STATE OF WASHINGTON
DEPARTMENT OF ECOLOGY

Re: Further Action at the following Site:

- **Site Name:** Rainier Mall
- **Site Address:** 4208 Rainier Avenue South, Seattle, WA 98118
- **Facility/Site No.:** 88987973
- **Cleanup Site ID:** 4187
- **VCP Project No.:** NW3261

Detailed Ecology Comments on Remedial Investigation / Feasibility Study and Cleanup Action Plan (RI/FS and CAP), Rainier Mall Property

Figure 11
Groundwater Contour Map
 4/14/2020

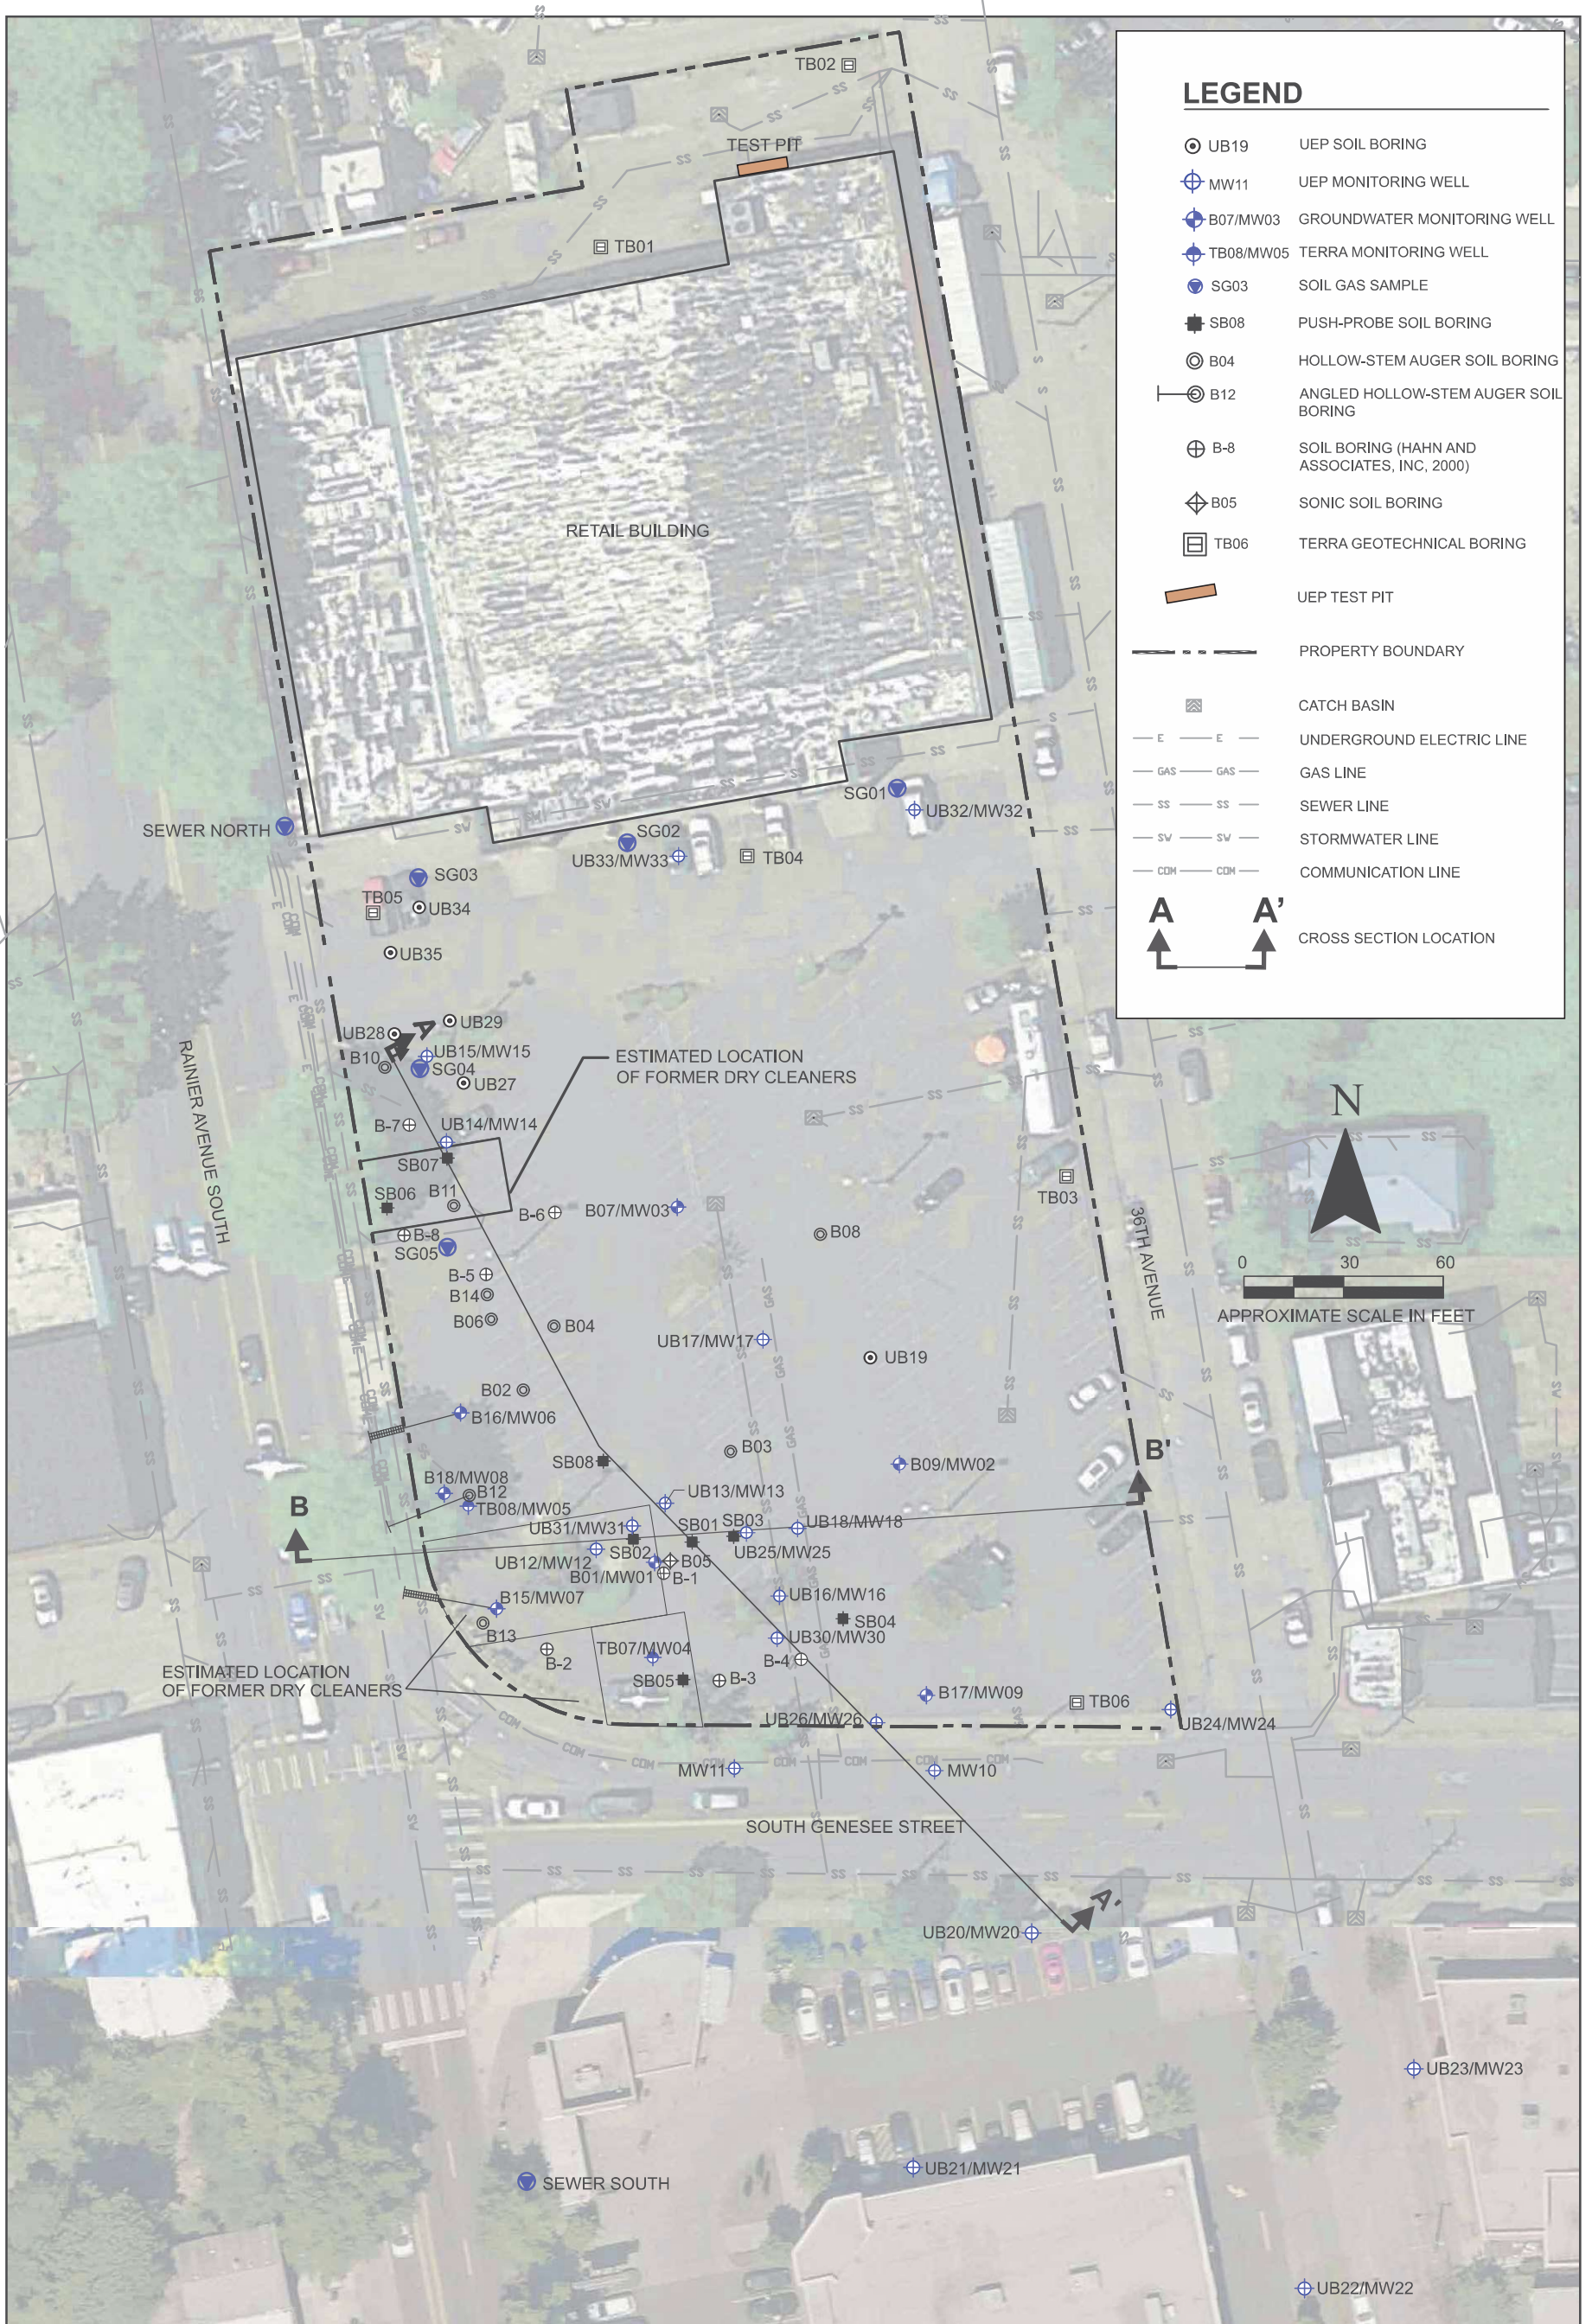
Groundwater: Static groundwater levels have been measured in monitoring wells at the Site between approximately 7 and 16 feet below ground surface (bgs). Monitoring well groundwater elevation data suggests groundwater flow approximately follows the filled stream to the southeast (**Figure 2**).

Figure 3
 Exploration Location Plan

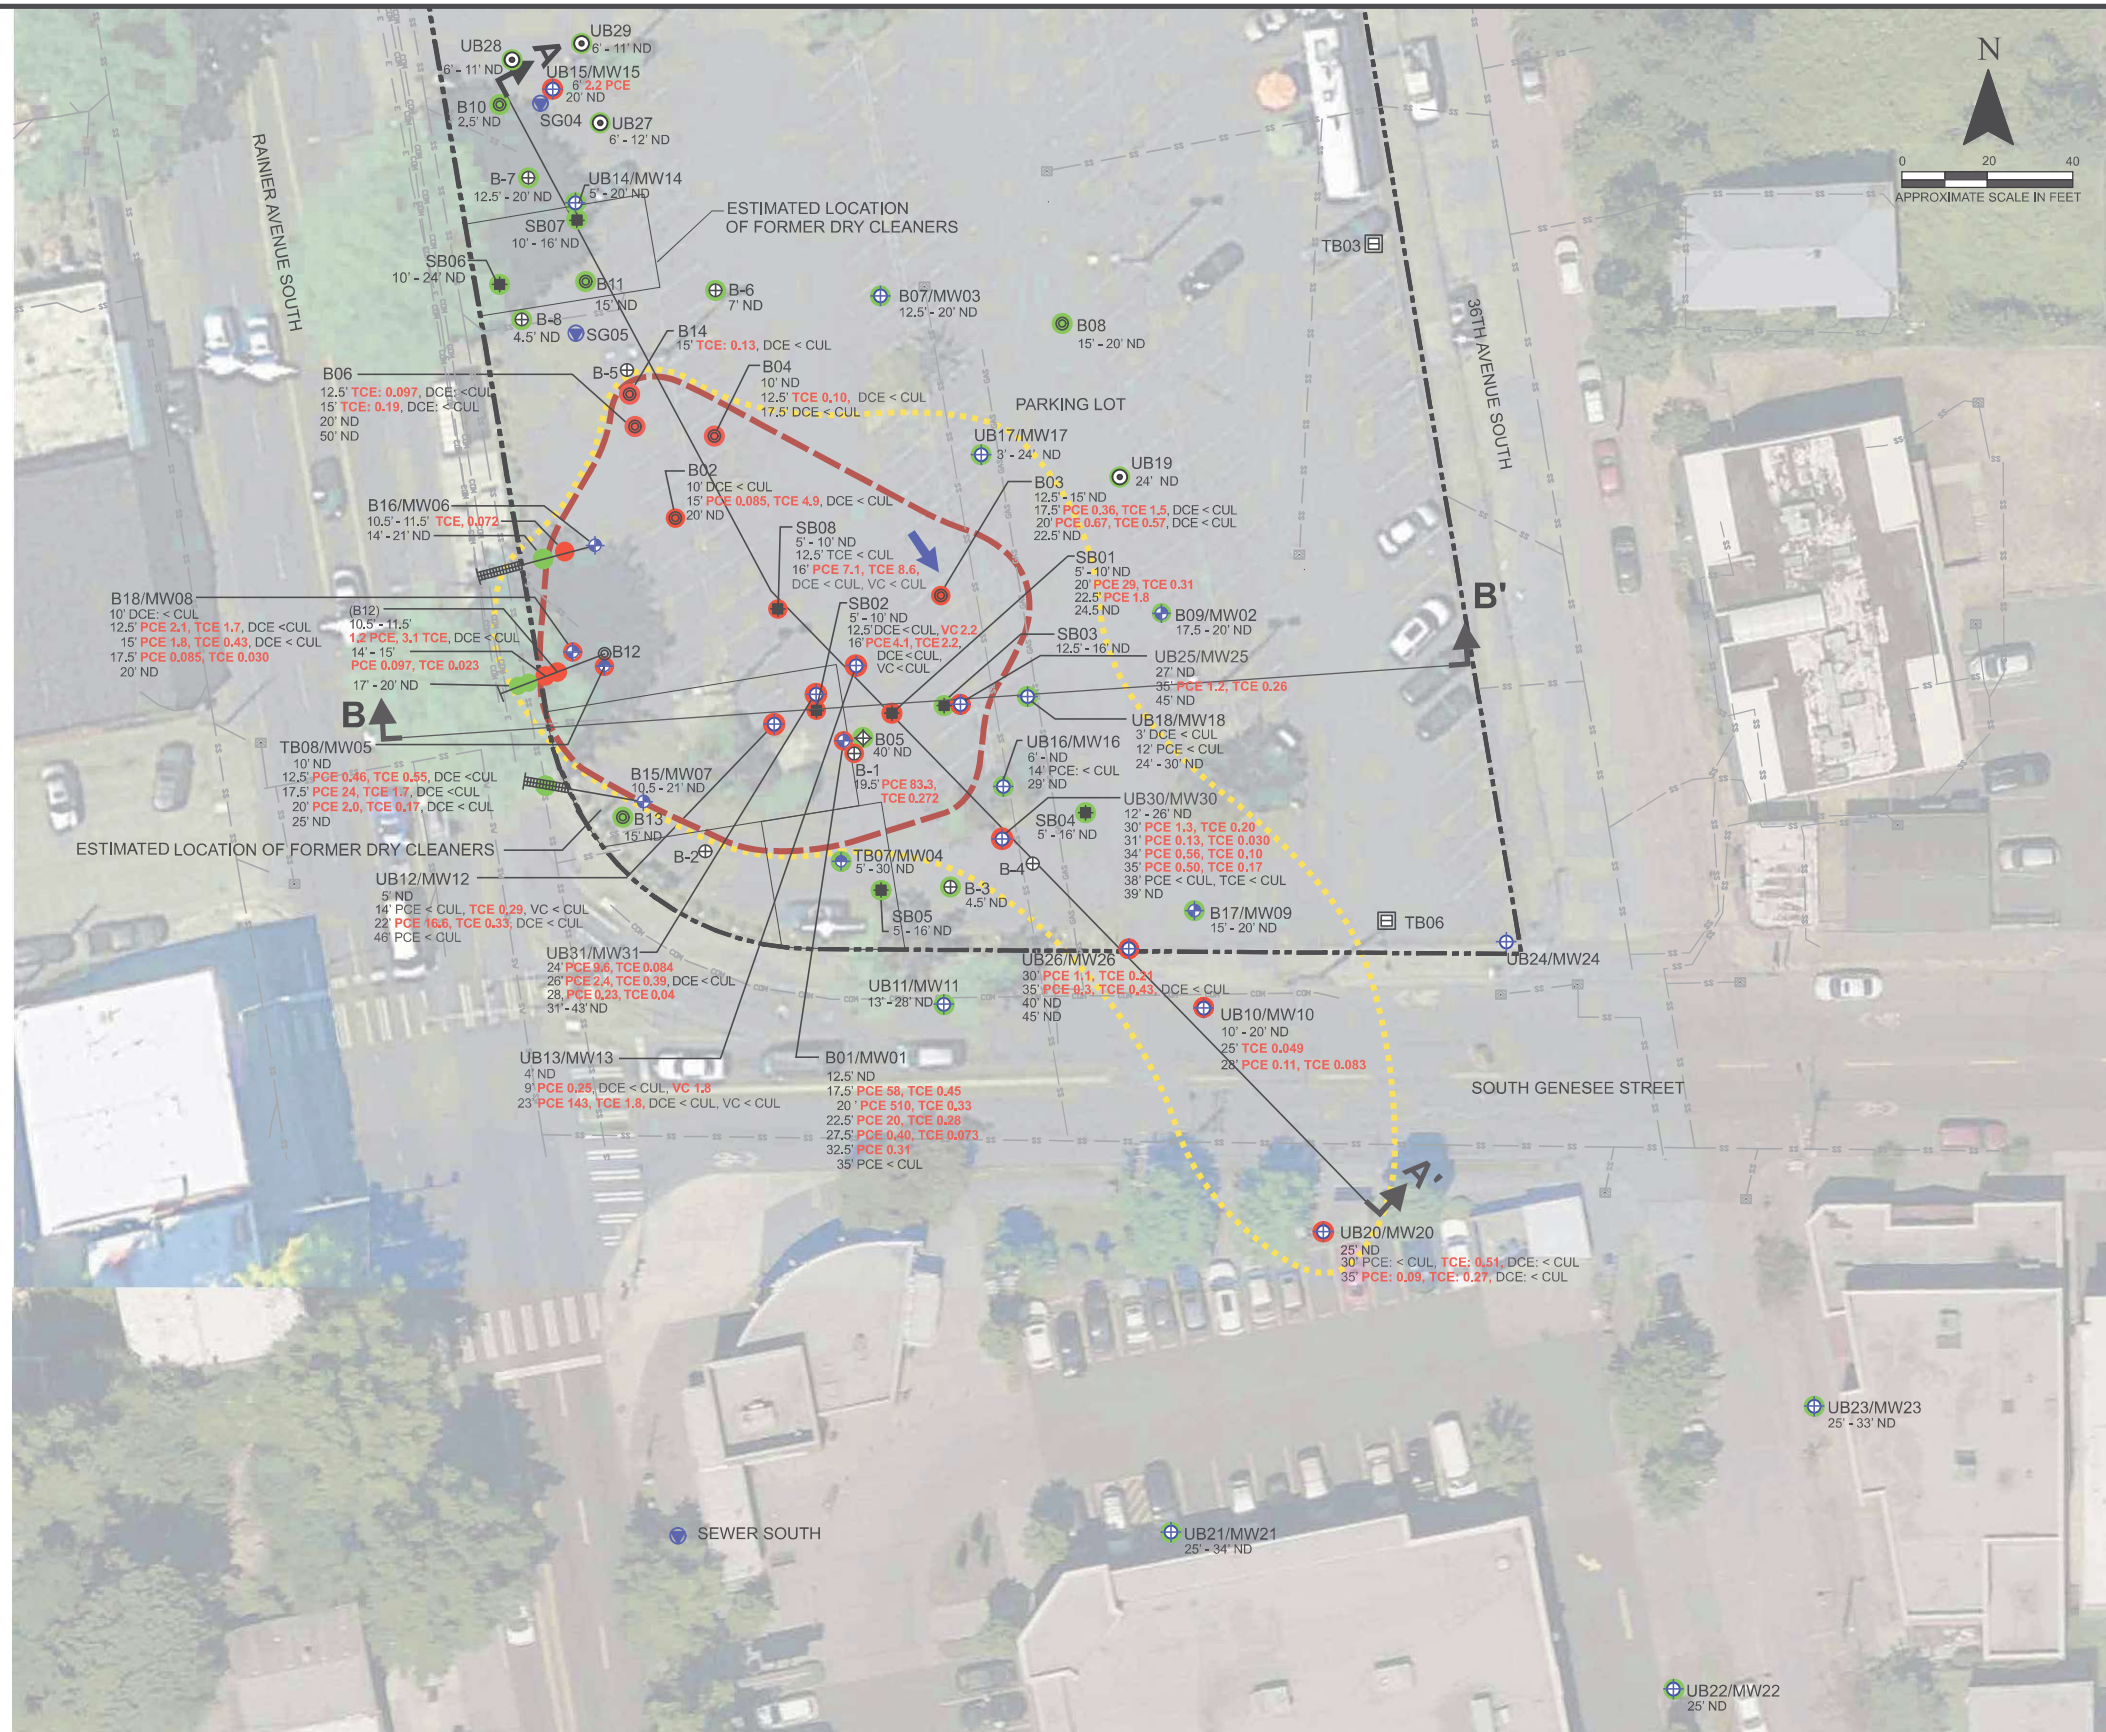
Sampling locations are shown on **Figure 3**. Chlorinated VOC concentrations exceeding CULs in soil samples collected from borings at the Site are shown on **Figures 4, 6 and 7**.

Figure 5
 CVOC Concentrations in Groundwater

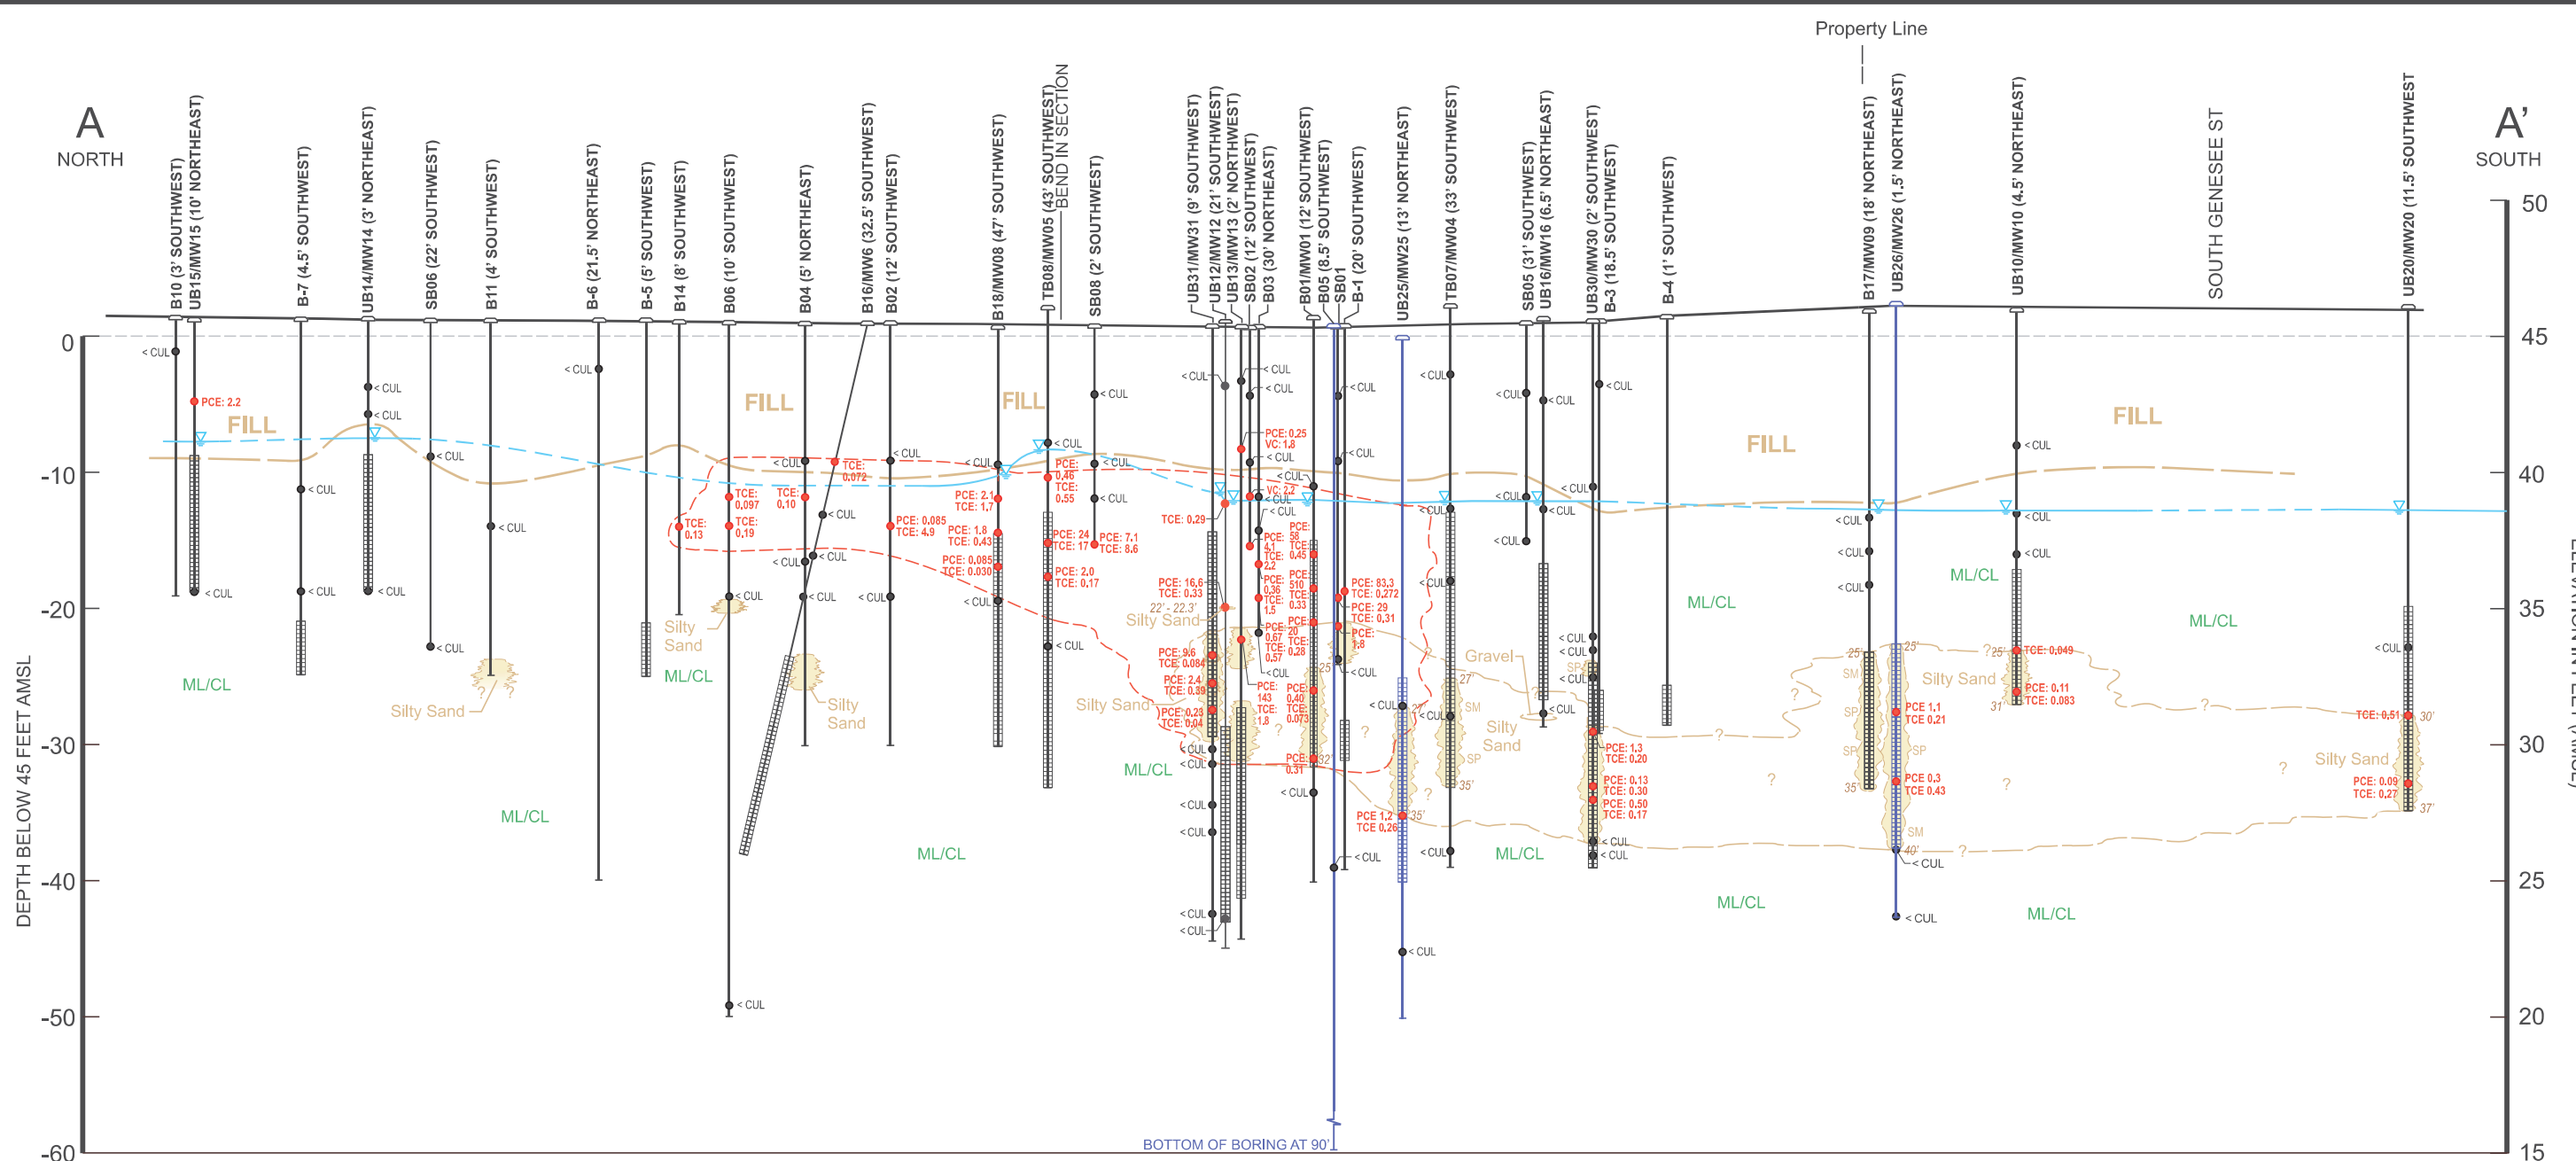
Chlorinated VOC concentrations exceeding CULs in groundwater samples collected from monitoring wells at the Site are shown on **Figure 5**.
